PD Modification Application: PRS 22-0232**Zoning Hearing Master Date:** N/A**BOCC Land Use Meeting Date:** February 8, 2022**Hillsborough
County Florida****Development Services Department****1.0 APPLICATION SUMMARY****Applicant:** Wendover Housing Partners, LLC**FLU Category:** SMU-6**Service Area:** Urban**Site Acreage:** 6.11 +/-**Community
Plan Area:** Riverview**Overlay:** None**Introduction Summary:**

The subject site is Parcel E-1 within PD 02-0060, as most recently modified by MM 20-0808. The overall PD is approximately 23 acres in size and comprised of seven parcels to allow for commercial, office and multi-family uses. Parcel E-1 is approved for commercial uses or 116 standard or senior multi-family units under an approved flex of the OC-20 Future Land Use Category under MM 20-0808.

2.4 Proposed Site Plan (partial provided below for size and orientation purposes. See Section 8.2 for full site plan)

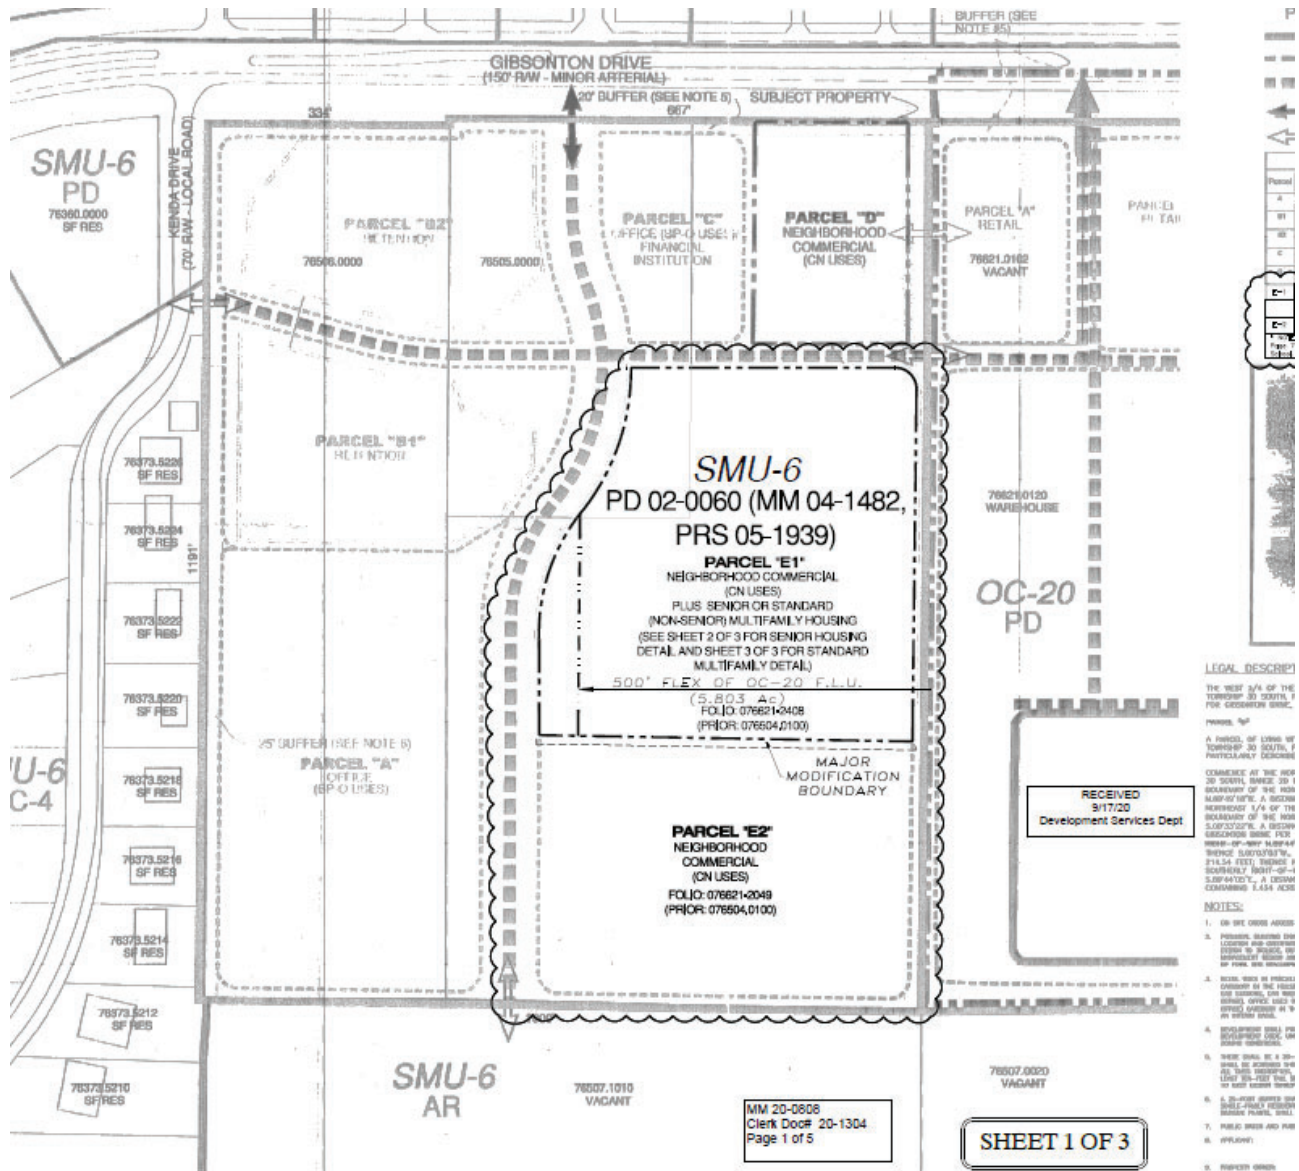
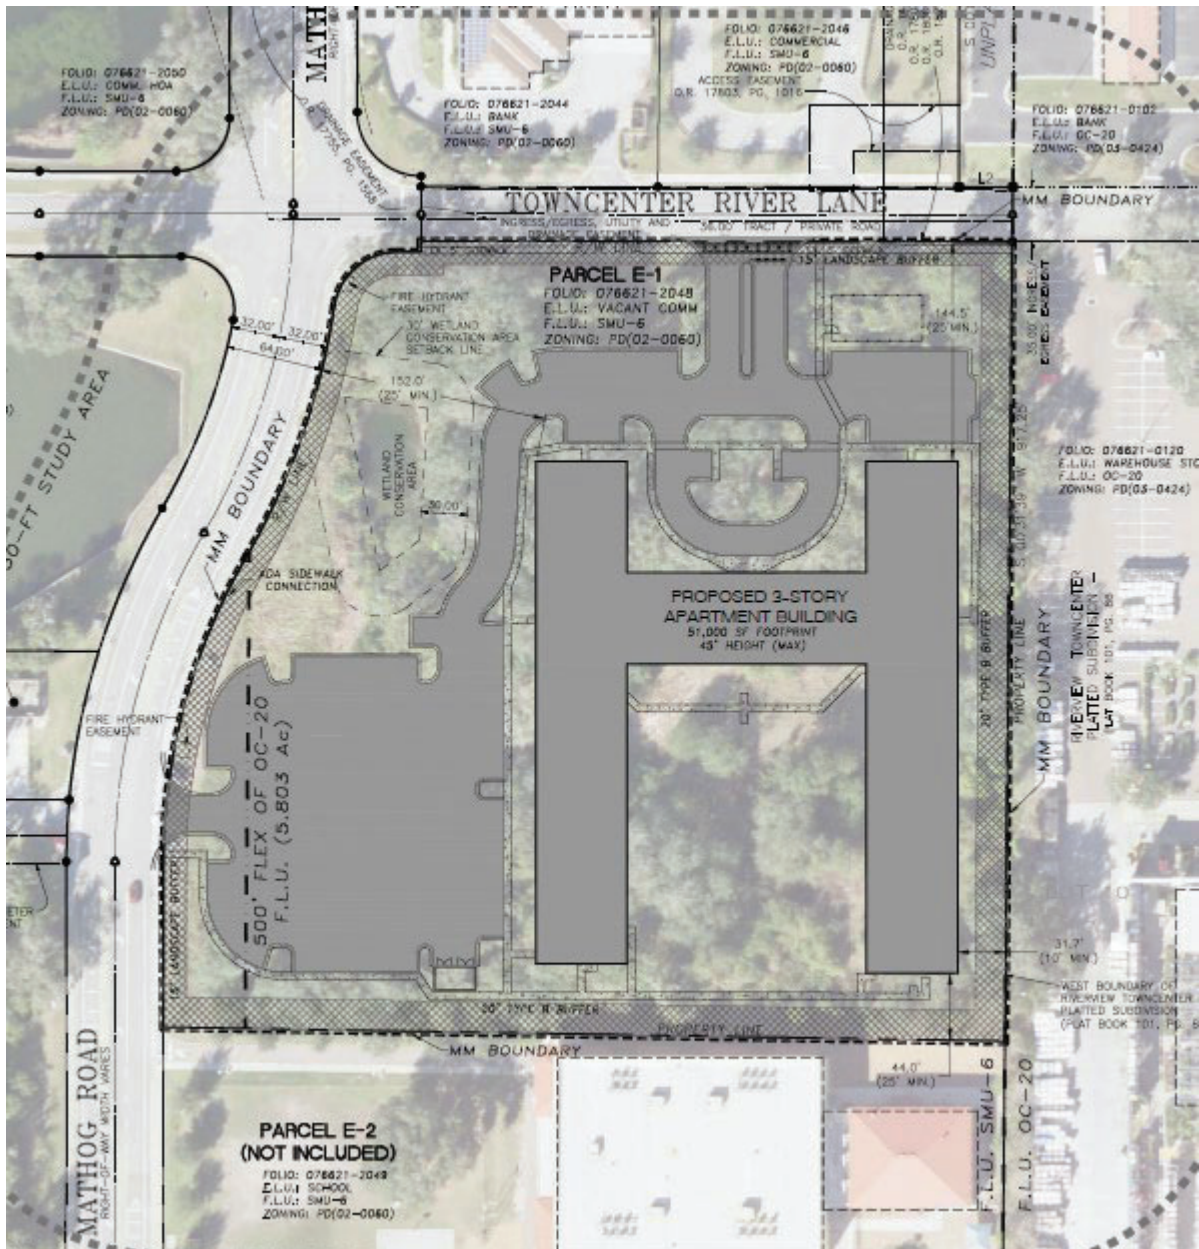
Existing Approval(s):	Proposed Modification(s):
Building footprint as approved under MM 20-0808	Modified building footprint as proposed under PRS 22-0232
Total building footprint of 31,473 sf	Increase the total building footprint to 51,000 sf
Northern building setback of 232.8 feet	Decrease northern building setback to 144.5 feet
Eastern building setback of 40 feet	Decrease eastern building setback to 31.7 feet
Southern building setback of 76.9 feet	Decrease southern building set back to 44 feet
Western building setback of 216.9 feet	Decrease western building setback to 152 feet
Parking area locations as approved under MM 20-0808	Modified parking area locations as proposed under PRS 22-0232
Northern driveway location as approved under MM 20-0808	Re-location of northern driveway approximately 100 to the east
Sidewalk layouts as approved under MM 20-0808	Modified sidewalk layout as proposed under PRS 22-0232

Maximum building height of 56 feet/4-stories (site plan only)	Reduce the maximum building height to 45 feet/3-stories (site plan only)

The subject parcel is internal to the PD with the requests resulting from a revised building design. The decrease of 11 feet / 1-story has already been approved and is now being reflected on the site plan. This has created corresponding changes in the building shape, footprint, setbacks and the site layout.

At a maximum building height of 45 feet, application of the 2:1 setback results in a minimum setback of 50 feet. This setback was met or exceeded along all boundaries except the eastern boundary under both the 56 and 45 foot building heights. Under the proposed plan, this setback will only be met along the northern and western boundaries. The eastern boundary abuts the parking lot of a shopping center at a setback of 31.7 feet. The southern boundary abuts the rear of a 2-story charter school building at a setback of 44 feet. Along both property lines, Type B screening is provided, which exceeds LDC requirements. Both abutting uses are non-residential and not expected to create any compatibility issues.

The building footprint increase results from a lowering of the building height and is not accompanied by any increase in the number of approved multi-family units.

Parking areas will be in the same locations as previously approved – to the north and west of the multi-family building. The proposed plan illustrates an expansion and update to these areas.

Staff recommends approval, subject to proposed conditions.

8.2 Proposed Site Plan (Full)

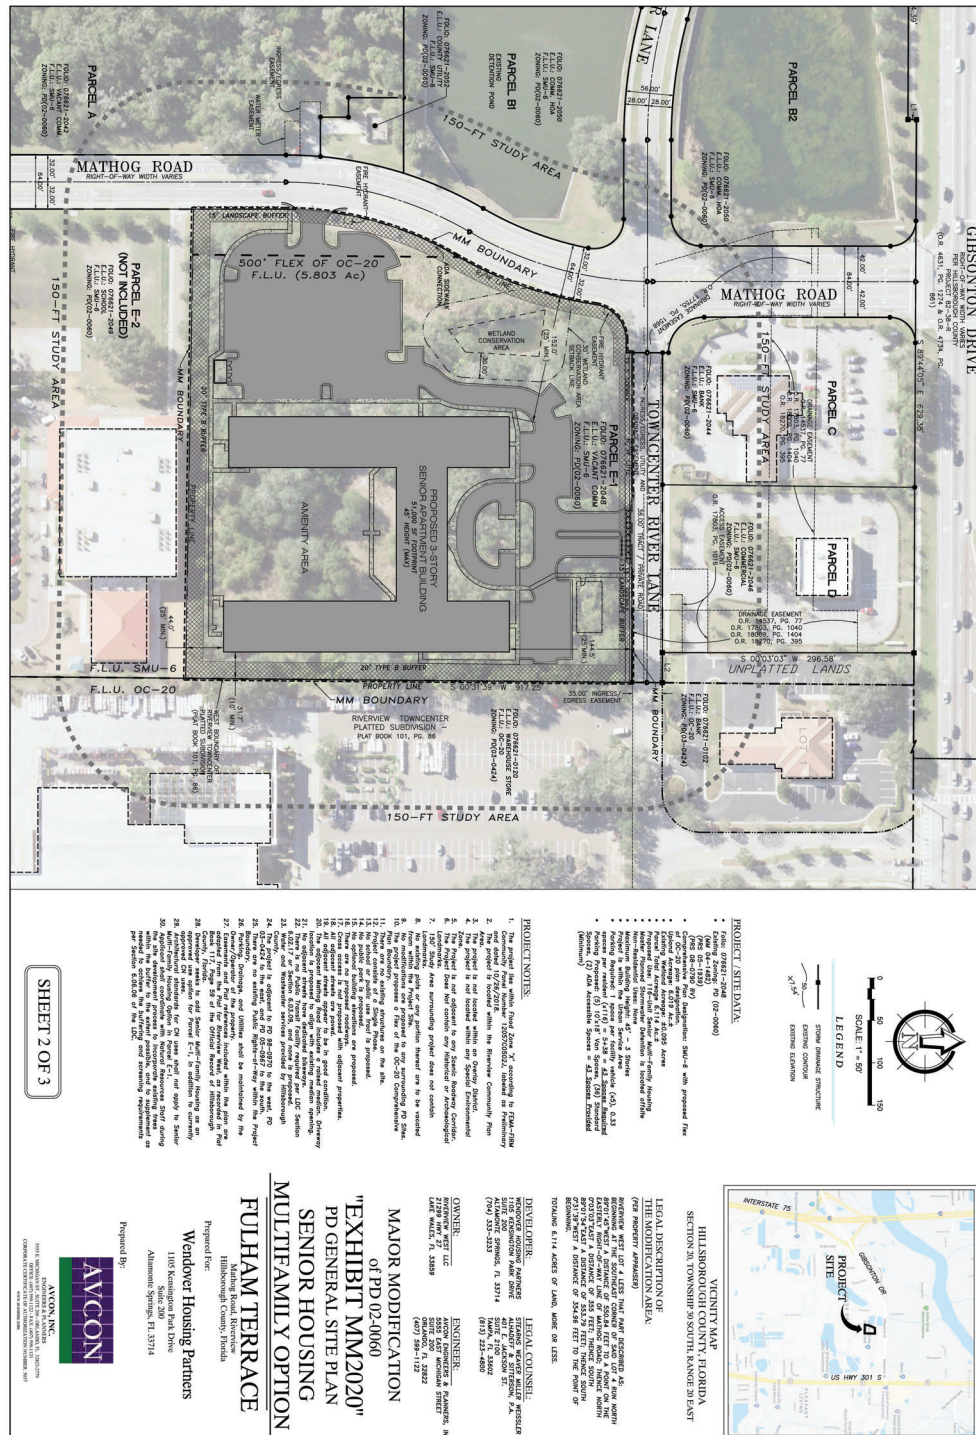
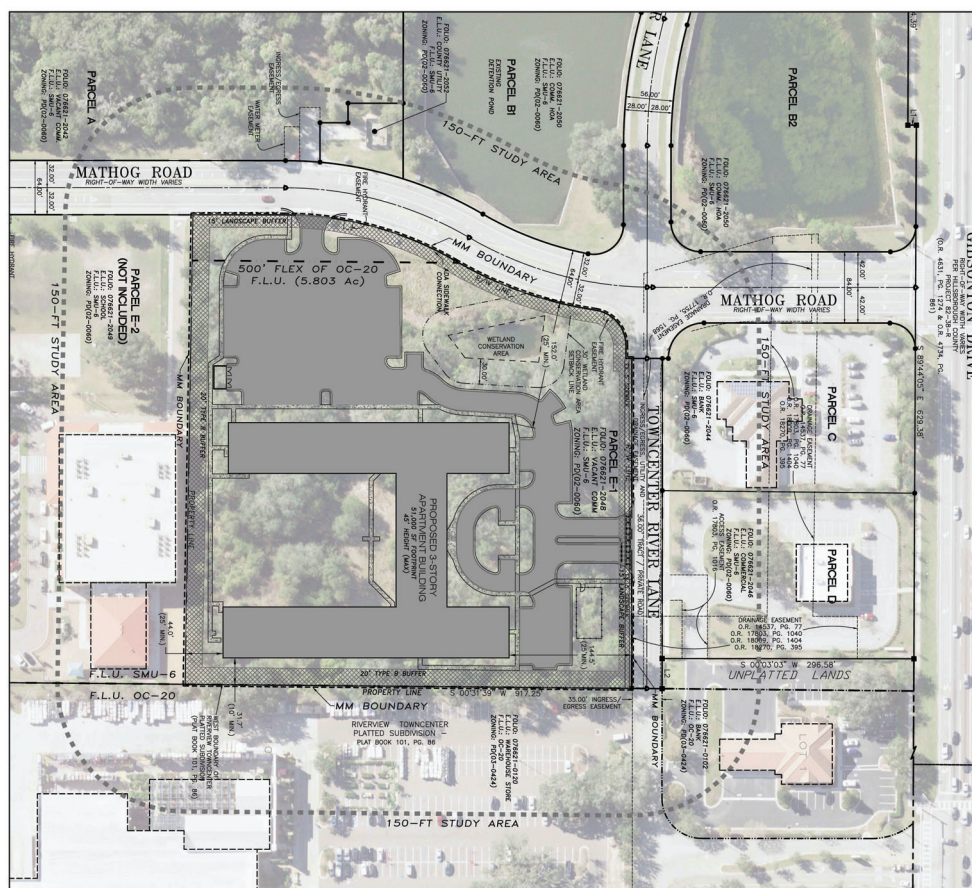
The applicant is requesting a Minor Modification (PRS) to PD #02-0060, as most recently amended via Major Modification (MM) 20-0808. The applicant is proposing to amend the site plan to reflect a new proposed building shape, as well as the height limitations agreed to during the previous MM approval. Other changes including shifting (to the east) the access along the driveway which runs along the project's northern boundary, such that it is located +/- 245 feet east of Mathog Rd.

Given that no new entitlements are proposed, and that access is not substantially changing, no trip generation or site access analysis was required to process this modification request. Staff has no objections to the proposed modification, subject to all previously approved, transportation related conditions of approval carrying forward.
